AGENDA
PLANNING COMMISSION
116 WEST NEEDLES
BIXBY, OKLAHOMA
July 15, 2013 6:00 PM

- ⑤ 3. **Preliminary Plat – Trails at Whitehawk – Tulsa Engineering & Planning, Inc. (PUD 62).** Discussion and consideration of a Preliminary Plat and certain Modifications/Waivers for “Trails at Whitehawk” for 75 acres in part of the W/2 SE/4 of Section 15, T17N, R13E.
Property located: Northwest corner of the intersection of 151st St. S. and Kingston Ave.
- ⑩ 4. **Preliminary Plat / Final Plat – Panda Express – Crafton Tull & Associates, Inc. (PUD 67).** Discussion and consideration of a Preliminary Plat and a Final Plat and certain Modifications/Waivers for “Panda Express,” part of the NW/4 SW/4 of Section 25, T18N, R13E.
Property Located: 10535 S. Memorial Dr.

MINUTES
PLANNING COMMISSION
116 WEST NEEDLES
BIXBY, OKLAHOMA
May 20, 2013 **6:00 PM**

The Trails at White Hawk

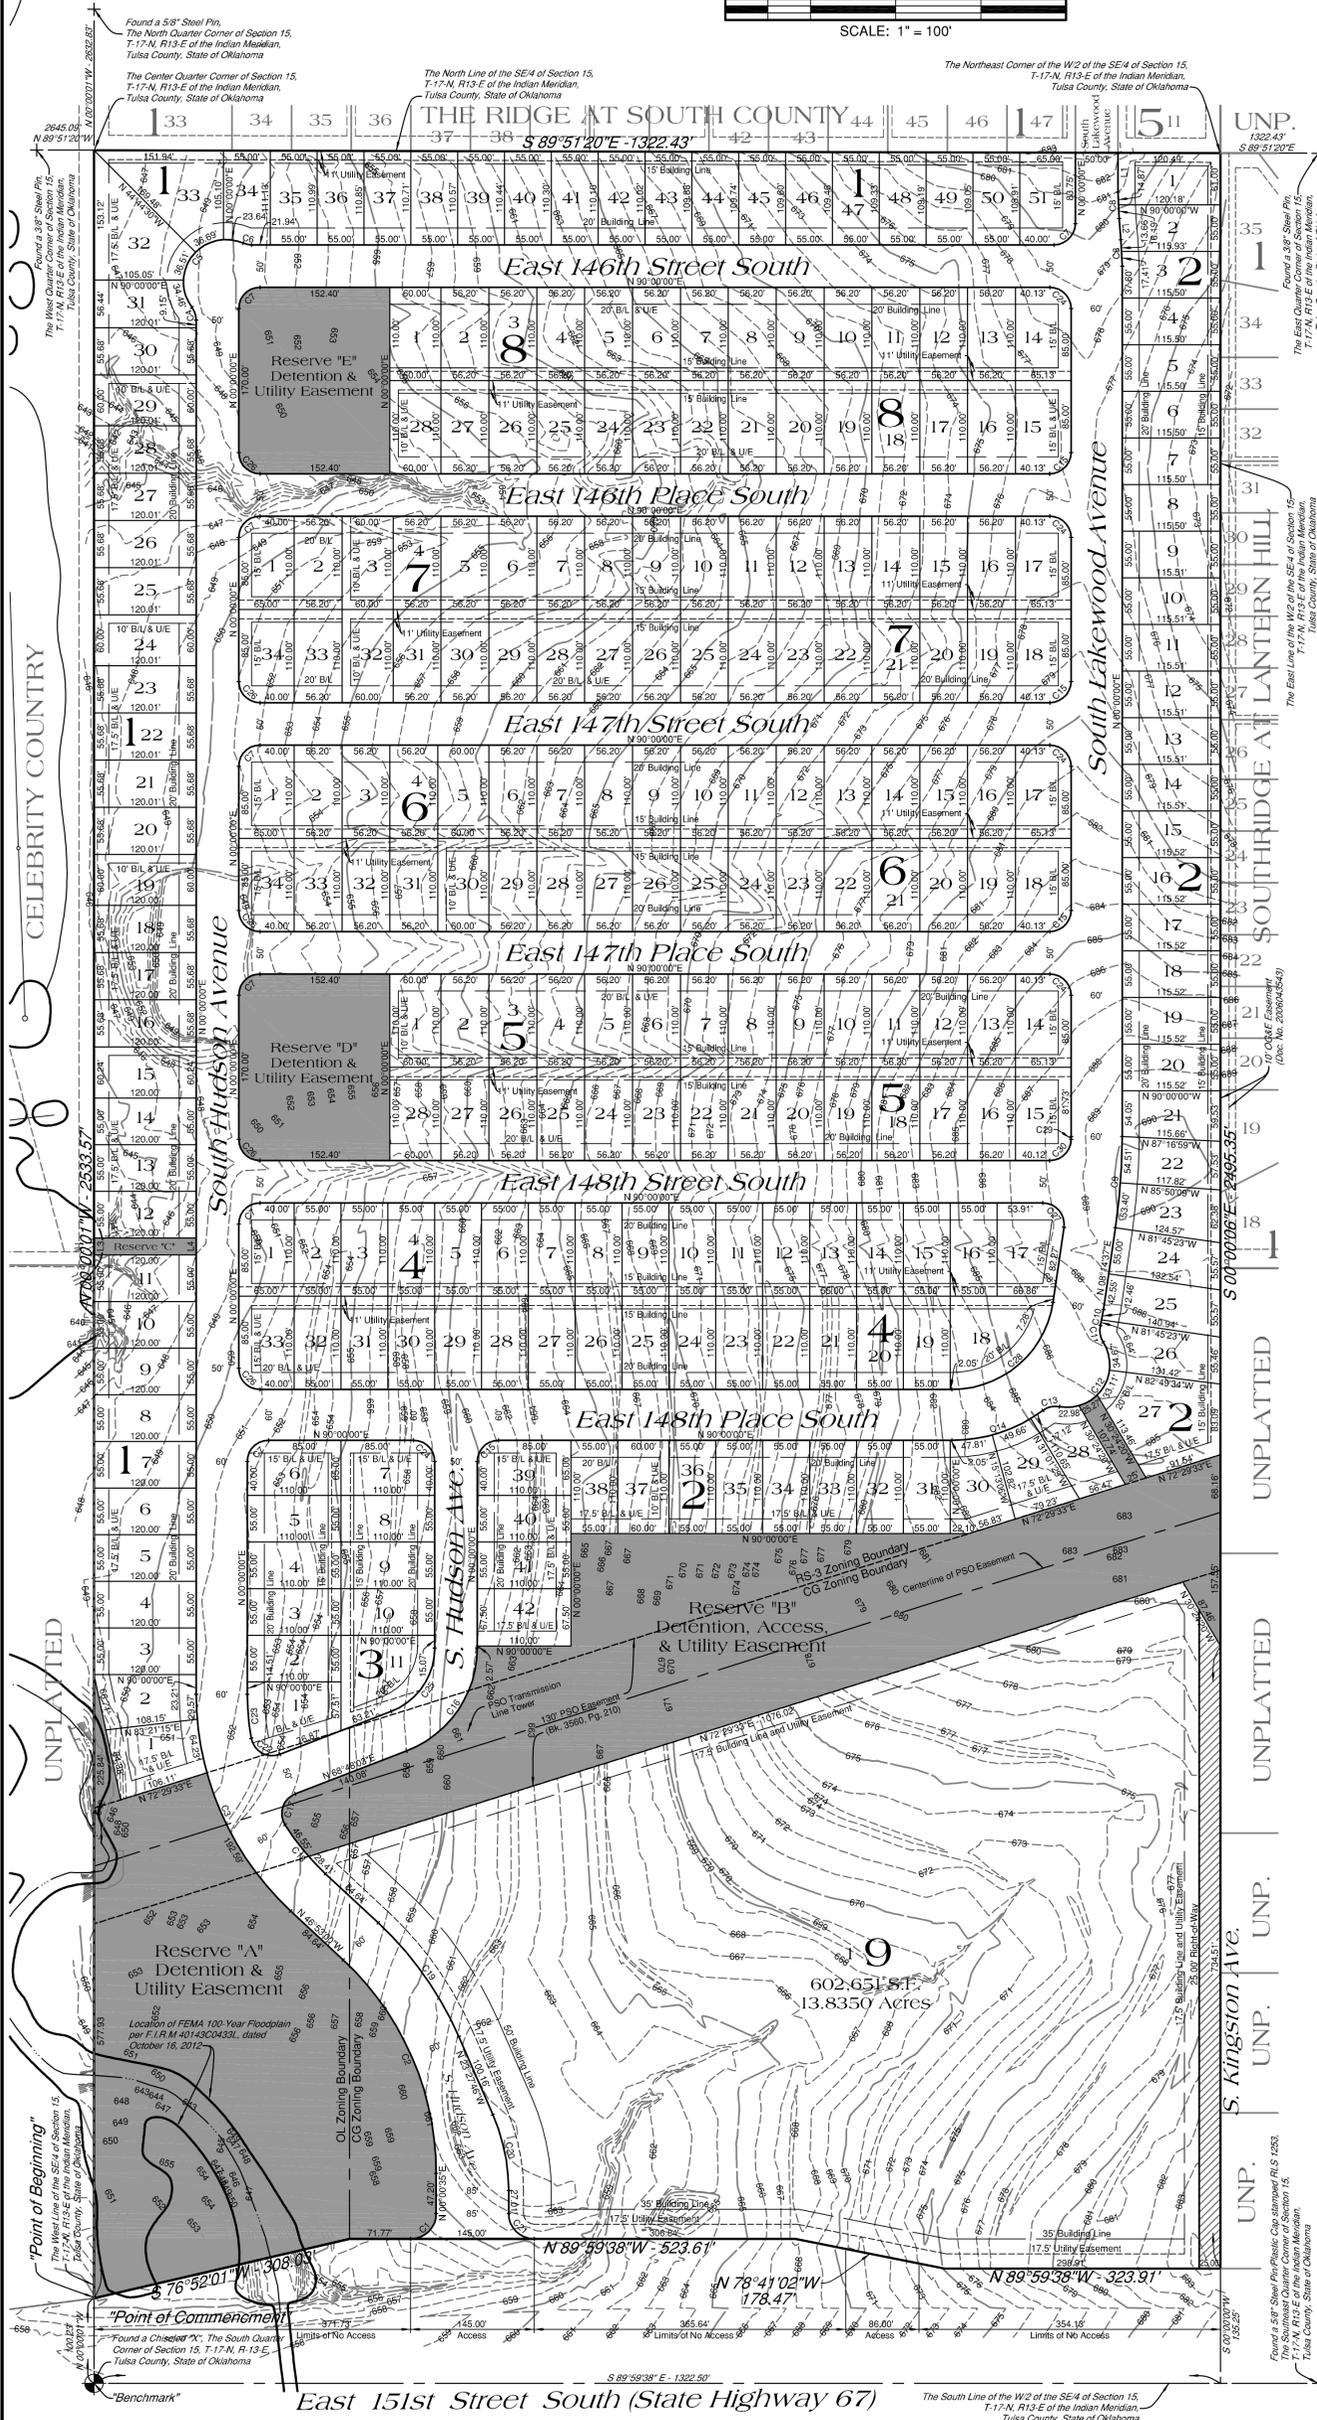
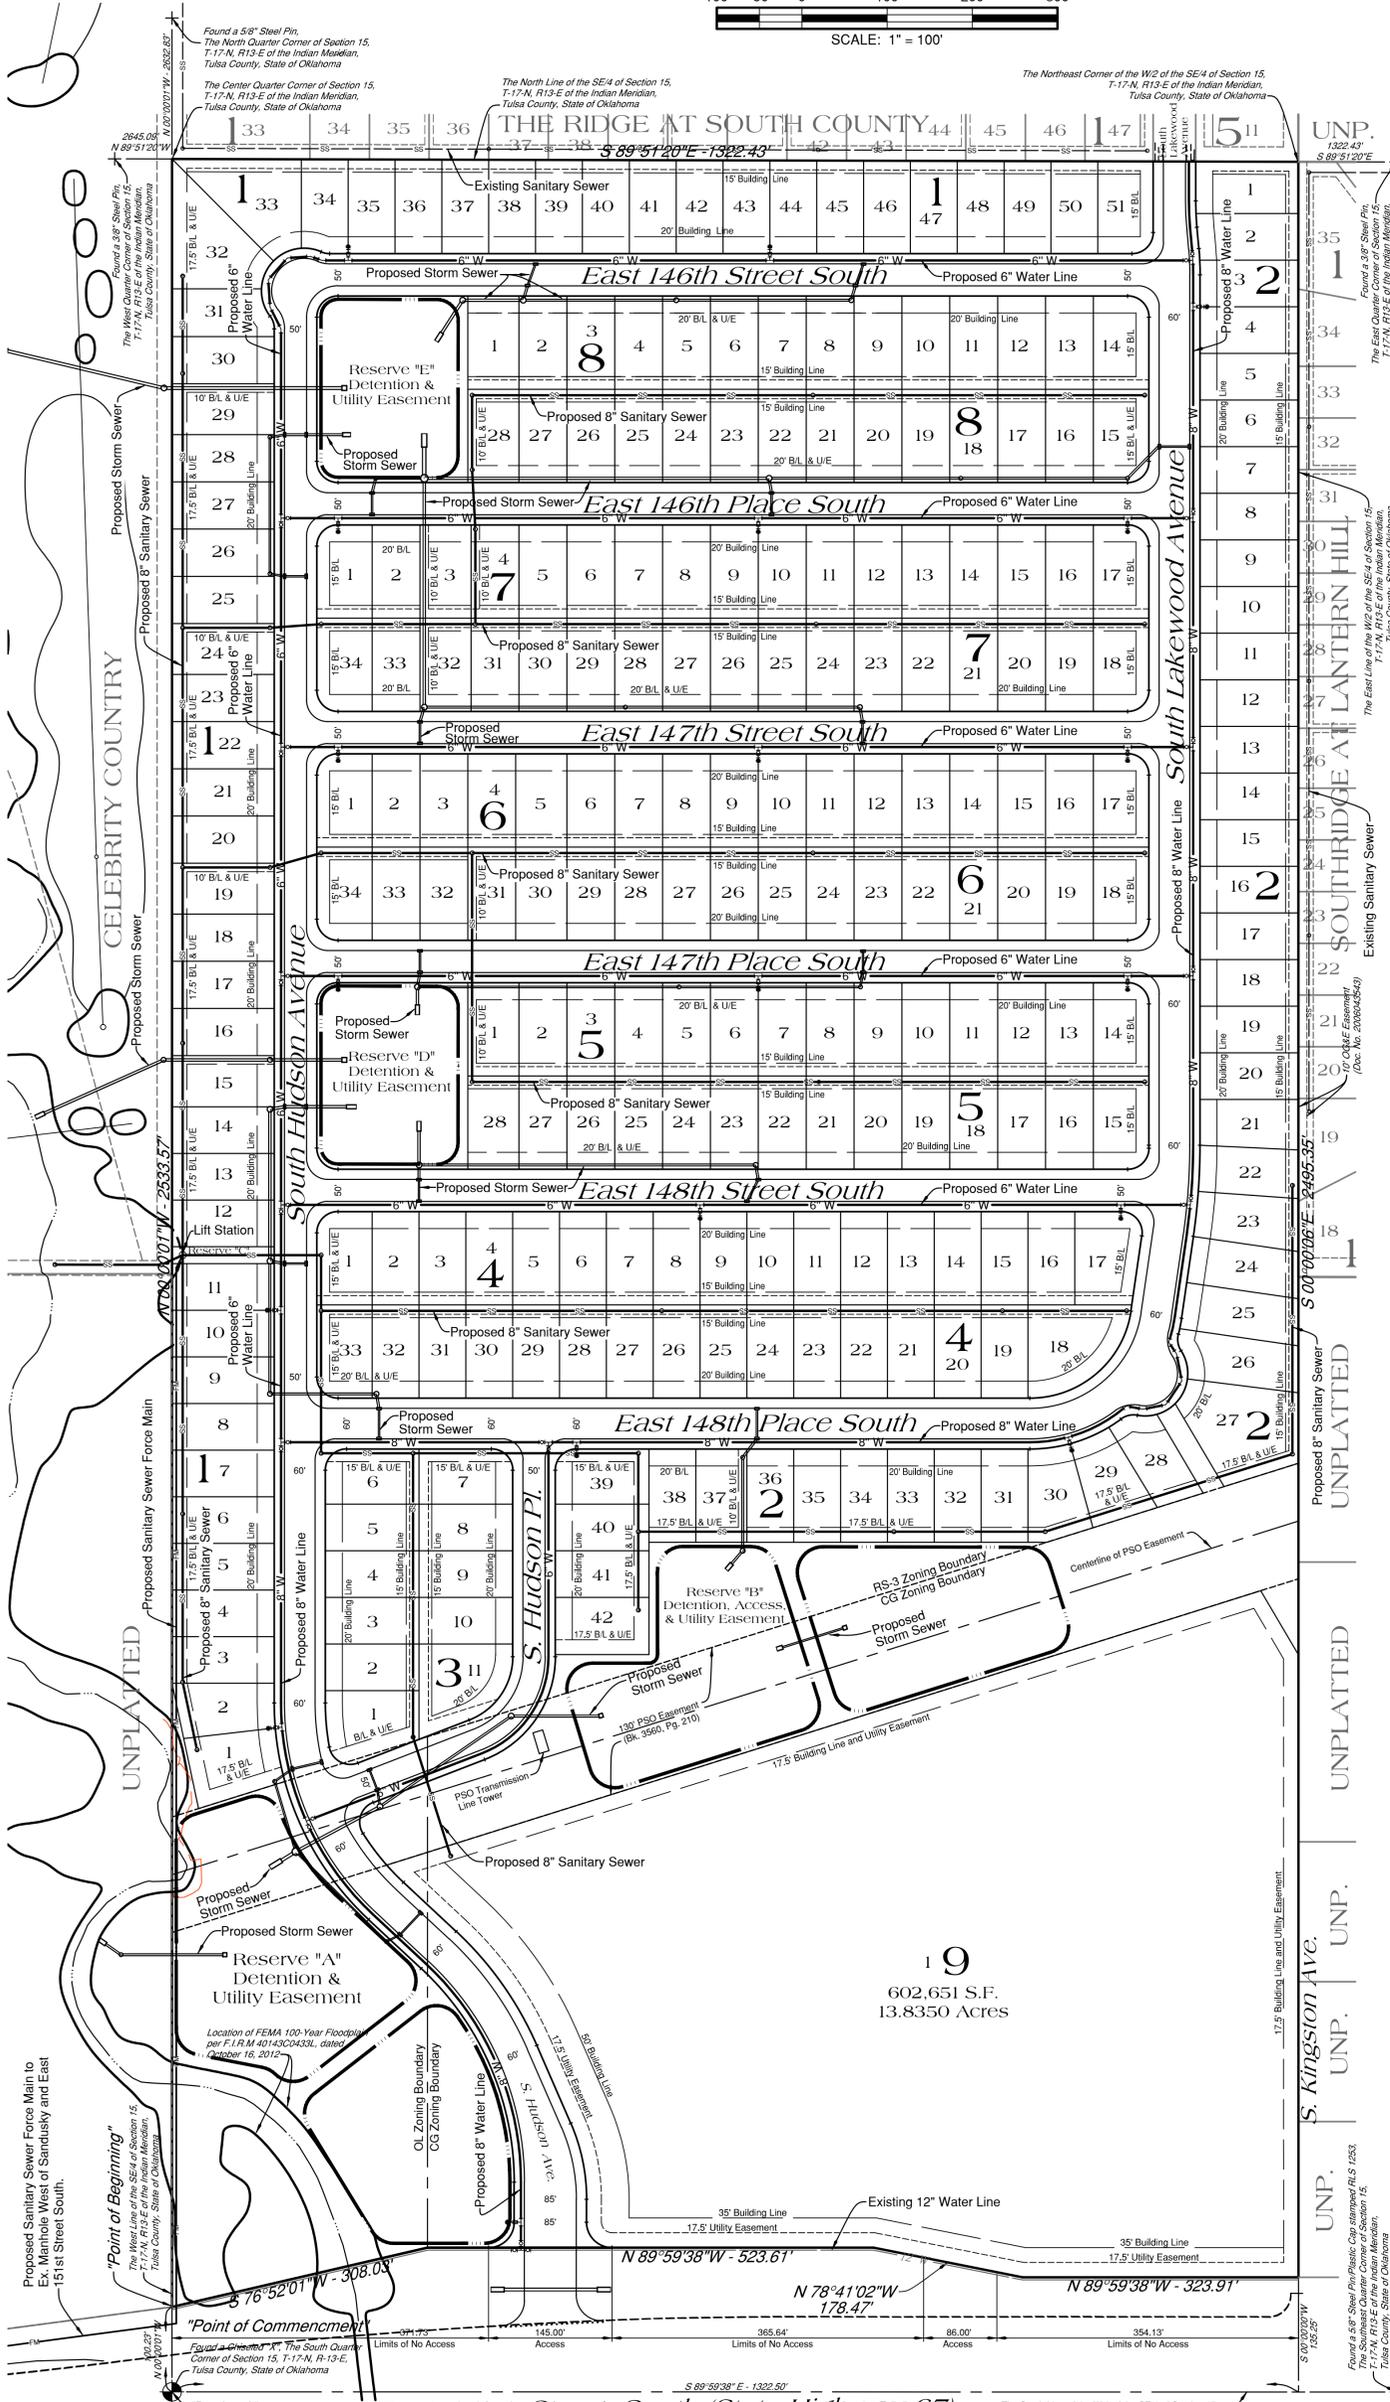
14. Lots 12 through 51, inclusive, Block 1, are completely separated from the balance of Block 1 by Reserve Area C. Per the definition of "Block" in the Subdivision Regulations and the typical block numbering conventions, the two (2) areas need to be separate blocks.

15. Lots 28 through 42, inclusive, Block 2, are completely separated from the balance of Block 2 by Reserve Area B. Per the definition of "Block" in the Subdivision Regulations and the typical block numbering conventions, the two (2) areas need to be separate blocks.
